**FINAL DRAINAGE REPORT  
FOR  
MC CLINTOCK STATION LOT A  
(VOLLMER ROAD RV STORAGE)**

**June 2022  
Project No. 25251.00**

**Prepared By:  
JR Engineering, LLC  
5475 Tech Center Drive  
Colorado Springs, CO 80919  
719-593-2593**

EXISTING DRAINAGE MAP  
 VOLLMER RV STORAGE  
 JOB NO. 25251.00  
 06/23/2022  
 SHEET 1 OF 1

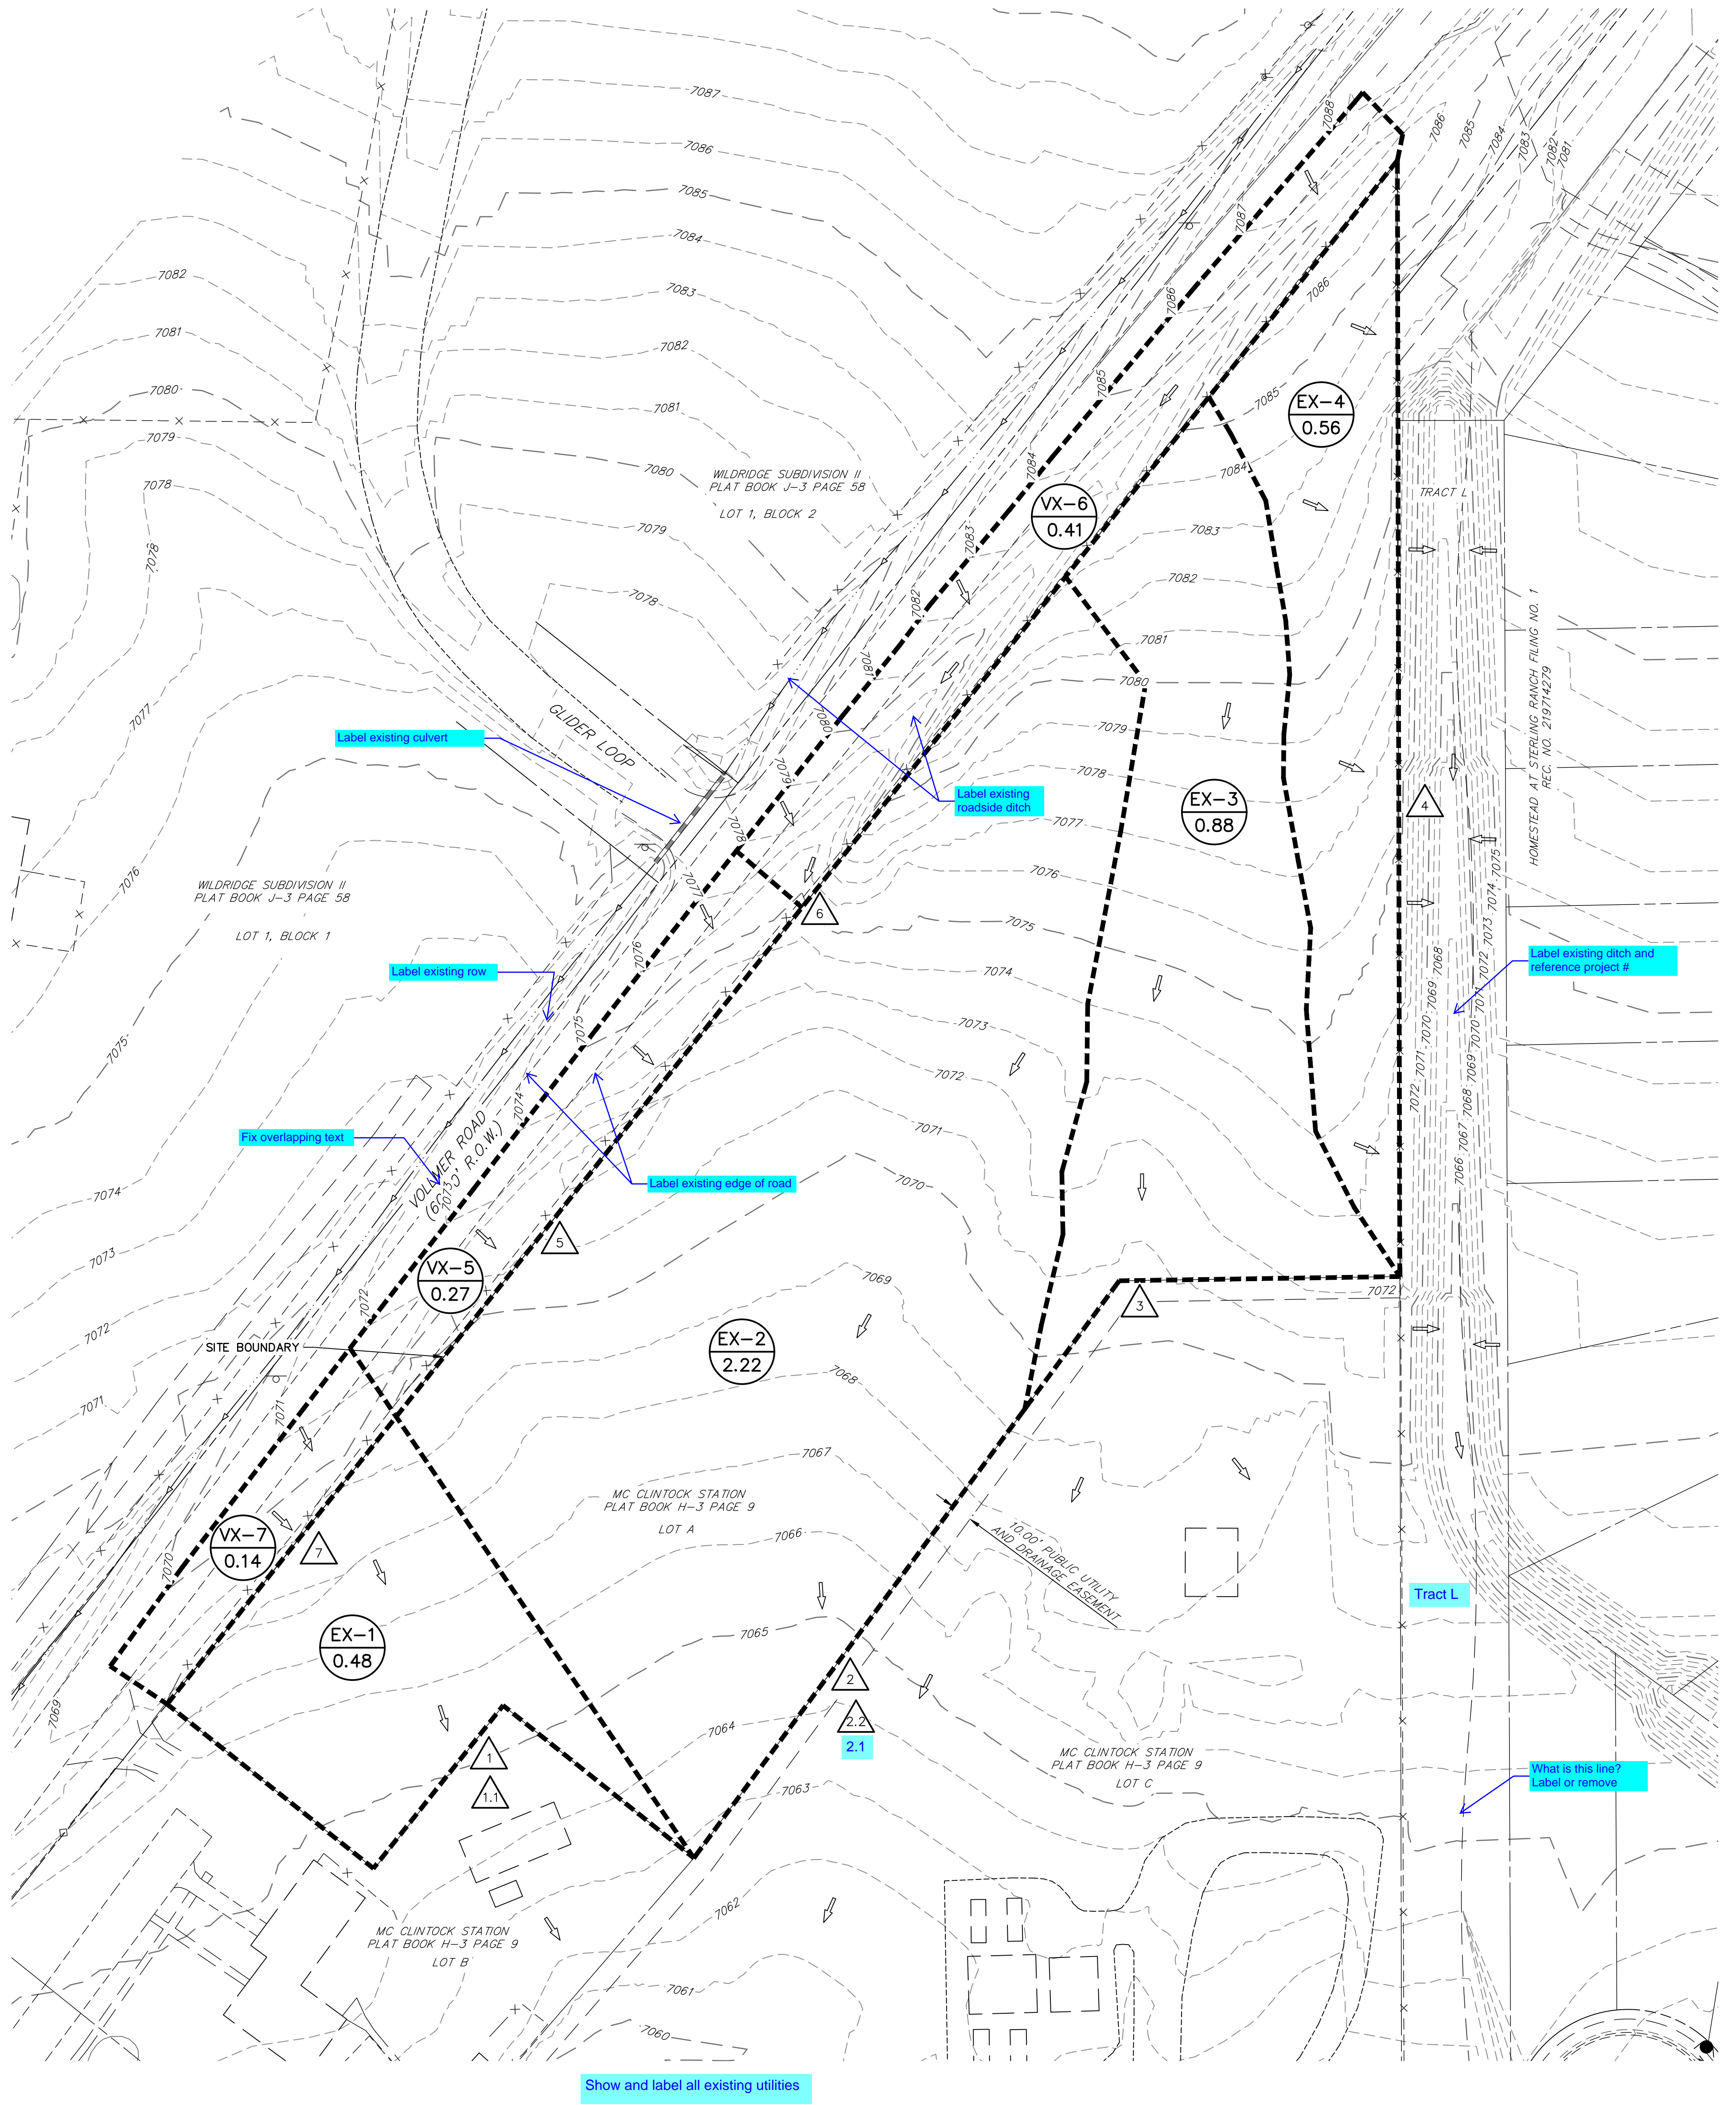
Show and label all existing utilities
